ADDENDUM NO. 1

MARKET STREET IMPROVEMENTS and FIFTH STREET ACTIVE TRANSPORTATION STP-5507(607) & TAP-5445(613)

COUNTY OF JEFFERSON, MISSOURI

April 3, 2026

XS SHEET
 SHEET 19 OF 20
 KIMMSWICK GREAT
 STREETS PHASE I

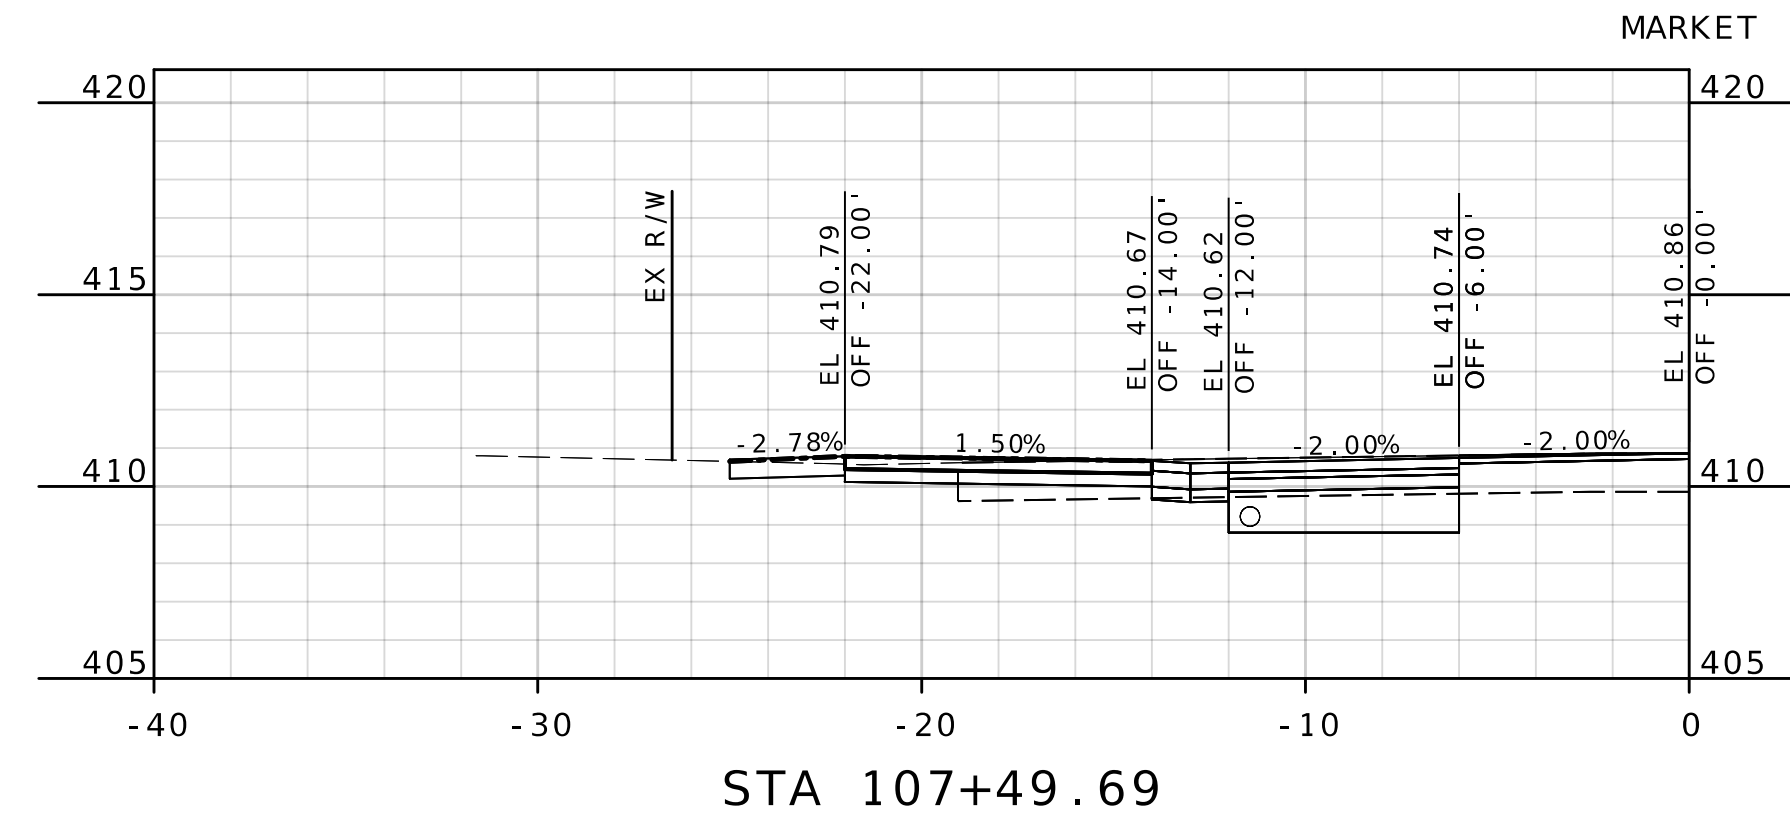
XS Sheet 18 of 20 and XS Sheet 19 of 20 have revisions to the cross sections.
